South Texas Project Electric Generating Station P.O. Box 289 Wadsworth, Texas 77483

December 4, 2008
U7-C-STP-NRC-080067

South Texas Project
Units 3 and 4
Docket Nos. 52-012 and 52-013

Commitment Related to Tsunami Effects and Response to Request for Additional Information

Figure 20. Time series of hypothetical “Monster” water surface elevation above MSL at 28.58 deg N and 95.98 deg W (i.e., buoy location shown in Figure 1). Datum referenced to MSL

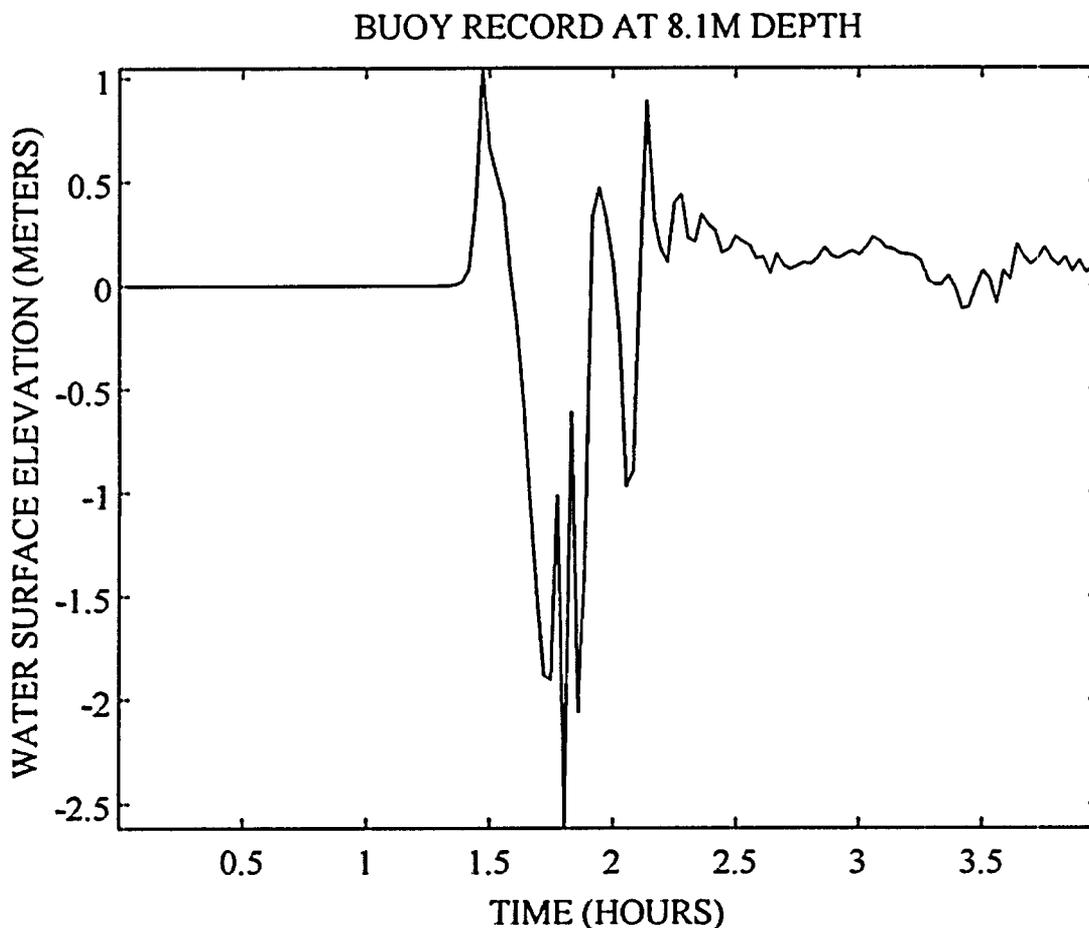
[Item 1] Provide an assessment (e.g., tsunami modeling analysis) of the East Breaks landslide to clarify whether the 7.6 m offshore wave height indicated by Trabant et. al. (2001) can be discounted.

MOST output includes run-up estimates (i.e., maximum inland elevation inundated by the tsunami above MSL). Maximum run-up ranges from 1 to 2 m (3.3-6.6 ft) (MSL) for the South Texas coast near STP 3 & 4 (Table 1). Plots of maximum wave amplitude relative to South Texas coast bathymetry are shown for PV, PV(x20), PNG, and the hypothetical “Monster” cases in Figure 13, Figure 15, Figure 17, and Figure 19, respectively. Time series and period of water surface elevation above MSL for a buoy location near the South Texas coast for the PV, PV(x20), PNG, and hypothetical “Monster” are shown in Figure 14, Figure 16, Figure 18, and Figure 20, respectively.

Figure 21. Sands in the MCR near STP 3 & 4.

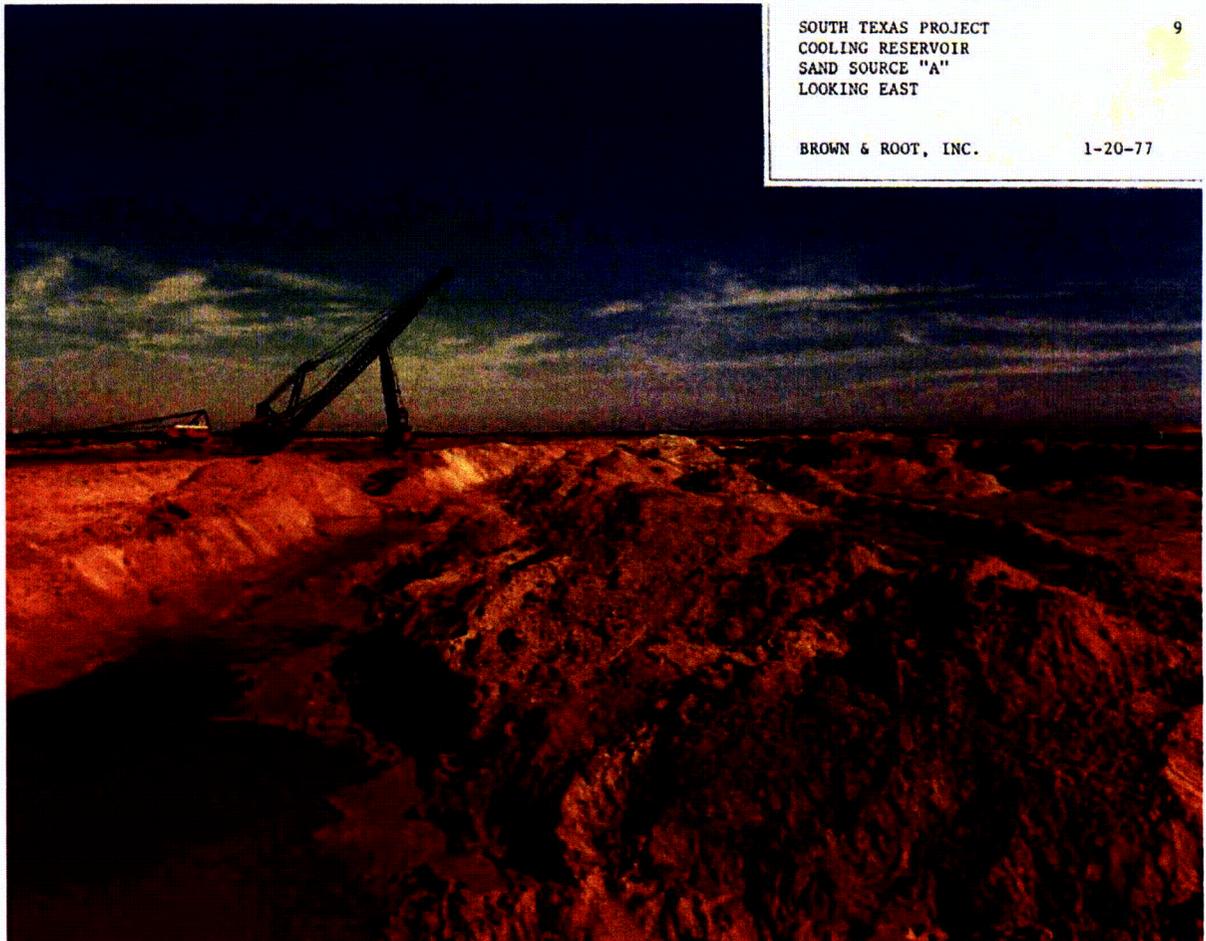
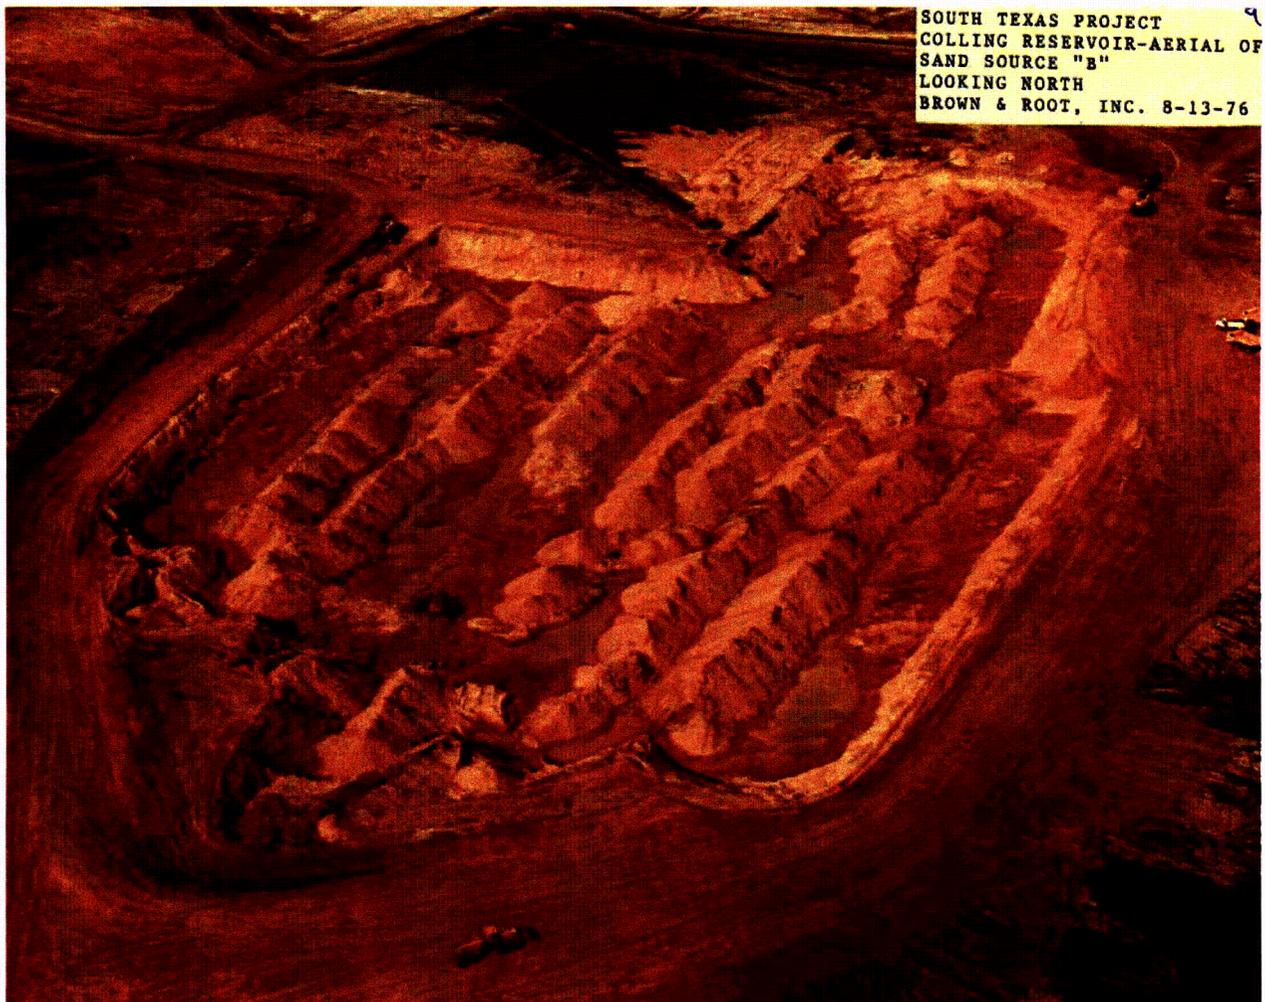
[Item 4] *Provide excavation photos from Units 1 and 2.*

In response to Item 4, excavation photos are provided in Figure 21, Figure 22, and Figure 23. The excavation photos do not reveal any evidence of a tsunami at the location of the MCR or at STP 1 & 2.

Figure 1. Six arc-second topography and bathymetry for the South Texas Coast and Gulf of Mexico (Source: Reference 1). Elevations are in units of meters and relative to NGVD29 (MSL).75

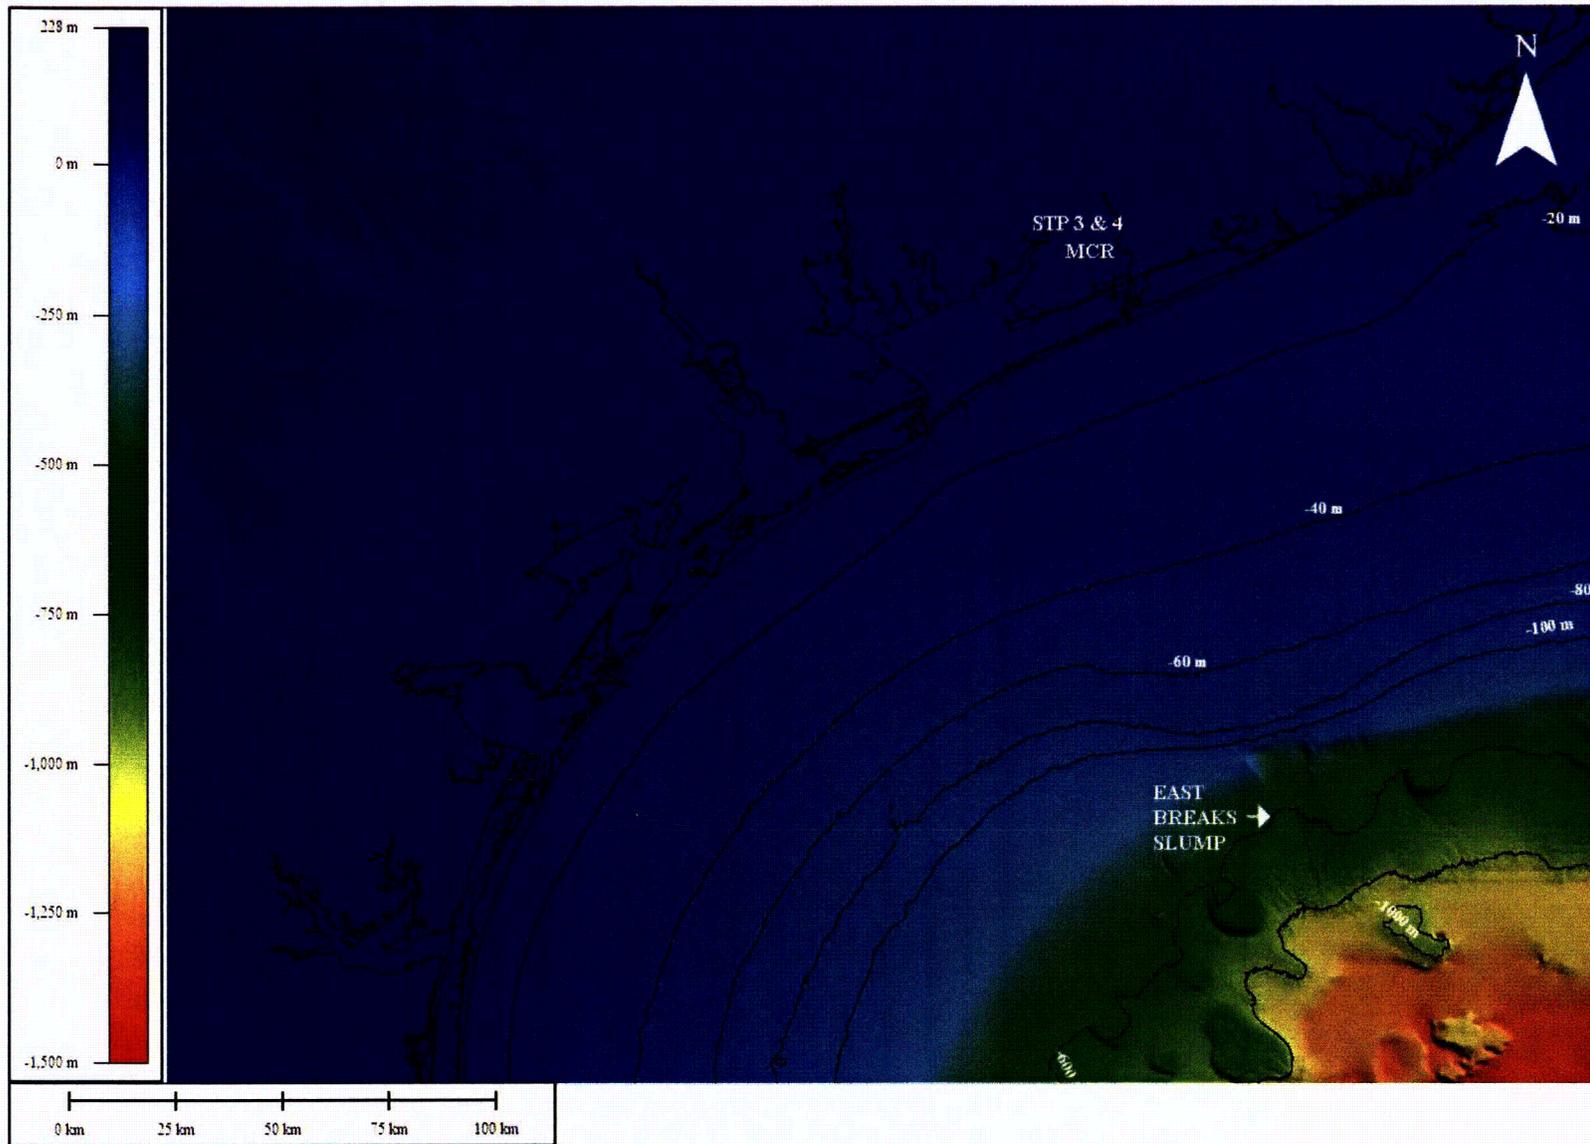
Section C.I.2.4.6.4 of RG 1.206 provides specific guidance with respect to tsunami analysis. This includes providing a complete description of the analysis procedure used to calculate tsunami wave height and period at the site. Provide available high-resolution processed radar data at and near the site as well as the source for the bathymetric dataset used for tsunami analysis.

Processed high-resolution bathymetric data is downloadable from the National Oceanic and Atmospheric Administration (NOAA) National Geophysical Data Center (NGDC) (Reference below). Specifically, the gridded dataset of the US Coastal Relief Model from the NGDC database (Reference below) is the source of the bathymetric, as well as topographic data for the tsunami analysis as shown in Figure 1.
